- 4. Pace's Pleasant Haven 2022 Replat  
KPB File 2022-168**

**PACE'S PLEASANT HAVEN 2022 REPLAT**

ITEM 4 - PACE'S PLEASANT HAVEN 2022 REPLAT

STAFF REPORT

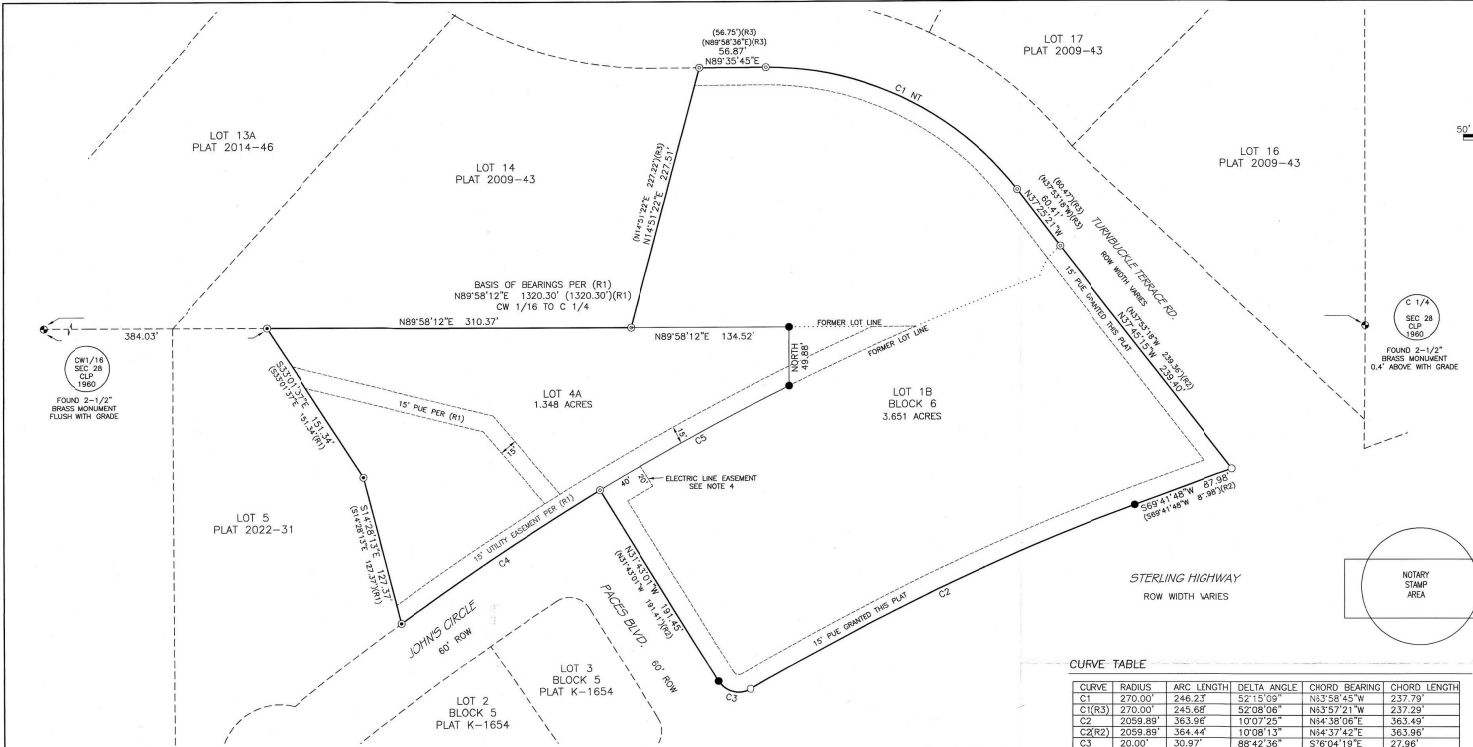
The block does not close. Johns Circle ends in a cul-de-sac. Proposed Lot 1B has improvements that limit the continuation of Johns Circle to Turnbuckle Terrace Road. A continuation of Paces Boulevard would greatly affect the lots north of the subdivision in addition to splitting the intended Lot 4A. **Staff recommends the plat committee concur that an exception is not required, as any required dedication would not improve the block.**

**Site Investigation:** There are no low wet areas present within the subdivision. Some steep terrain does appear to be present where the existing driveway connects to Turnbuckle Terrace Road. As this is an existing drive and the City of Soldotna had no concerns, **staff recommends the terrain not be shown and no additional information is required regarding construction of access.**

Municipal sewer and water are not available. Lot 1B is combining lots and increasing available acreage. Lot 4A is decreasing 1.408 acres to 1.348 acres. A soils analysis report was performed for Pace’s Pleasant Haven Subdivision Addition No. 3, Plat KN 2022-31. Due to the location of the existing well and sewer on the neighboring lot the soils report showed the ideal location for the well would be in the northwest corner of Lot 4 and a test hole was done on the eastern portion of the subdivision. The analysis determined that the soils were not suited for a conventional system. The City of Soldotna Planning and Zoning Resolution PZ 2022-015 indicates city services are not available but expansion is planned. Due to the minor change in acreage, future city services, and that future systems will still need to comply with the previous supplied soils analysis report, **staff recommends the plat committee concur that a new soils report for Lot 4A is not required and additional plat notes be added to show the previous reports findings and how the soils report may be obtained.**

**Utility Easements** Several easements have been granted by recorded documents and are depicted if locations are known and plat notes have been added. 15 foot utility easements within parent Lot 4 were created by Pace’s Pleasant Haven Subdivision Addition No. 3, Plat KN 2022-31 and are depicted. **Staff recommends the labels be revised from “Per” to “granted by”.**

The 15 foot easement within Lot 4A should include the original notation. **Staff recommends a plat note be added or a label that states “centered on existing power poles including poles, anchors, and guys.”**

Along Turnbuckle Terrace Road a 10 foot utility easement was granted by Eastgate Subdivision, Plat KN 2009-43, within Lot 15. **Staff recommends** either a depiction of the ten foot be added citing Plat KN 2009-43 or a plat note be added or note 2 be revised to state 10 foot was created by Plat KN 2009-43 within parent lot 15 and is being increased by 5 feet for a 15 foot utility easement.

- Add recorded distance from CW1/16 corner to NW corner of Lot 4A

- Staff recommendation:** The parent legal description needs to be updated.
- C. The location, width, and name of existing or platted streets and public ways, railroad rights-of-way, and other important features such as section lines or political subdivisions or municipal corporation boundaries abutting the subdivision;

- Staff recommendation:** Within the dedication is the frontage road, Whistle Hill Loop. Update the labeling to indicate that the subdivision is access from Whistle Hill Loop.

**Staff recommendation:** Correct overstrikes

**Staff recommendation:** The frontage road is within the Sterling Highway dedication, the ROW width varies label may remain but the depiction should go to within 100 feet or to centerline if further than 100 feet.

**Staff recommendation:** Place the following notes on the plat.

- "No access to state maintained rights-of-way permitted unless approved by the State of Alaska Department of Transportation."

- Include a plat note to clarify the 15 foot utility easement per R1 is “centered on existing power poles including pole, anchors, and guys.
- Add a plat note for any new easements being granted if clarification is needed.
- Add a plat note for any new easements granted by recorded document since the title report was prepared.
- If concurrence is granted by the Plat Committee add, “Pace’s Pleasant Haven Subdivision Addition No. 3, Plat KN 2022-31, had a soils analysis report prepared for Lot 4 and found the soil conditions unsuitable for conventional onsite wastewater treatment and disposal systems. A new soils report was not required for Lot 4A and the parent subdivision soils report is available from the Kenai Peninsula Borough.

The recording district shall be added to notes 4-6.

**Staff recommendation:** Additional documentation for signatures is required and updates to signature lines may be required. Staff is working with the owner for the documentation. Add which former lot the trust and LLC is signing on behalf of. Comply with 20.60.190.
